ETB Rev0 Errata List

Document number: **ETB-PRDC-001103 17.0**
Date of Issue: 11 February 2011
Author: ARM

This document describes the known errata in the Embedded Trace Buffer design.

Figure 1: Waveform Diagram

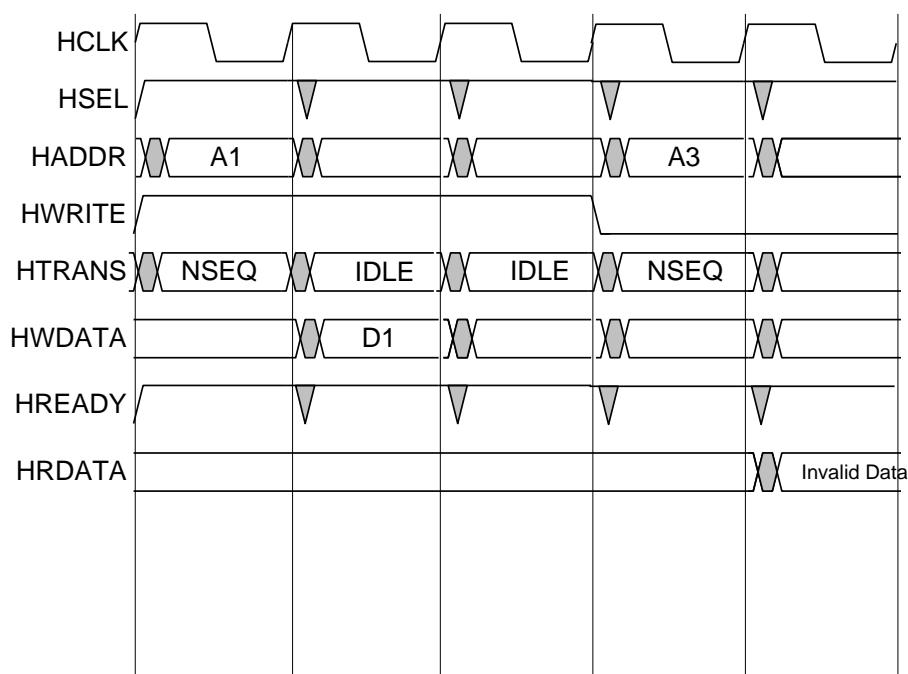
During an AHB transfer, if an IDLE transfer with HWRITE HIGH is made to the ETB RAM, then an ETB RAM read directly following this transfer will be invalid. An undefined value is written to the intended RAM read address and the returned read value is undefined.

HWRITE must be high during the AHB IDLE cycle with the ETB selected. This is usually because HWRITE is held at its last value between AHB transfers. If HWRITE is driven low during AHB IDLE cycles, this erratum does not occur.

There are no known workarounds for this erratum in existing designs. For new designs, this erratum can be avoided by using the ETB in asynchronous mode (by tying **SBYPASS** to 0).

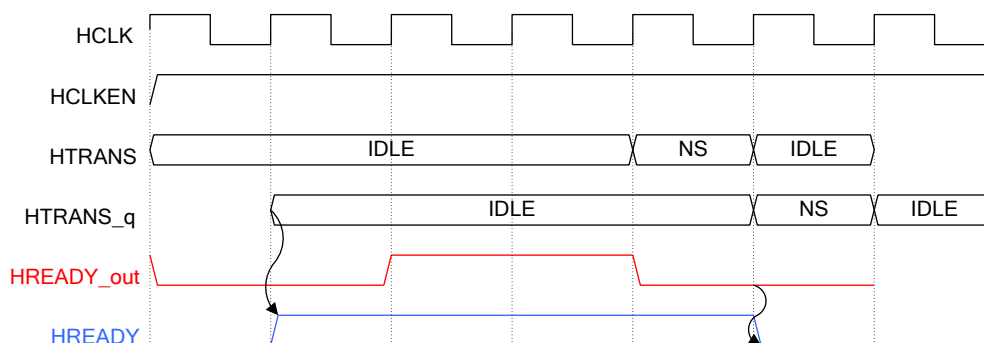
The HREADY output from the ETB might be driven low during the data phase of the IDLE or BUSY transaction.

The AHB master driving the ETB might assume that IDLE or BUSY transactions will always result in a zero wait-state response. This erratum might cause the AHB master to drive a new NSEQ or SEQ transaction on the AHB interface while HREADY is low and therefore causing the ETB to miss the new transaction.

The HREADY output from the ETB must be qualified based on whether an IDLE or BUSY transaction is in progress. It is important that this is done during the data phase of the transfer (second cycle) and therefore a registered version of HTRANS[1] should be used. While this registered version of HTRANS[1] is b0 HREADY must be high. This is shown in the following timing diagram example illustrating an IDLE transaction:
